UNITED STATES PATENT AND TRADEMARK OFFICE

APPLICATION NO.	FILING DATE	FIRST NAMED INVENTOR	ATTORNEY DOCKET NO.	CONFIRMATION NO.
09/917,749	07/31/2001	Yasutaka Ito	110575.01	2777

# Office Action Summary

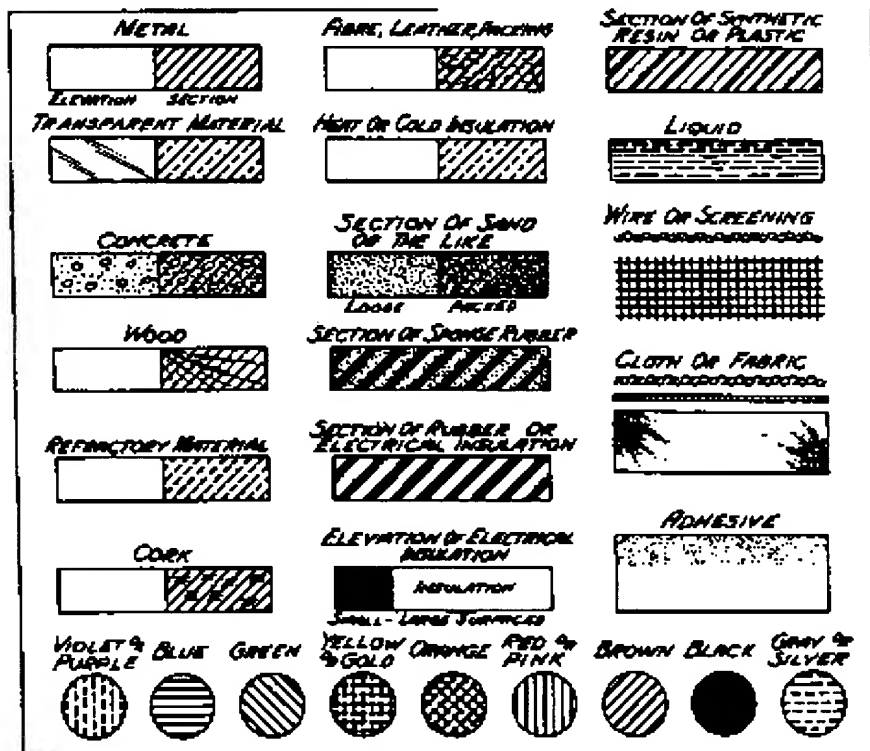
The drawings are objected to because of the following informalities:

Figs. 1-3, 5, 7-11, 13: Proper cross-sectional hatching is required to properly denote refractory materials in accordance with MPEP 608.02 (see the drawing below for proper hatching examples). The submitted proposed correction shows metallic hatching--not refractory hatching.

The response to this action must include a separate letter addressed to the examiner and contain: (1) sketches showing in red the drawing changes required above and (2) a request that the examiner approve the changes as shown on the sketches.
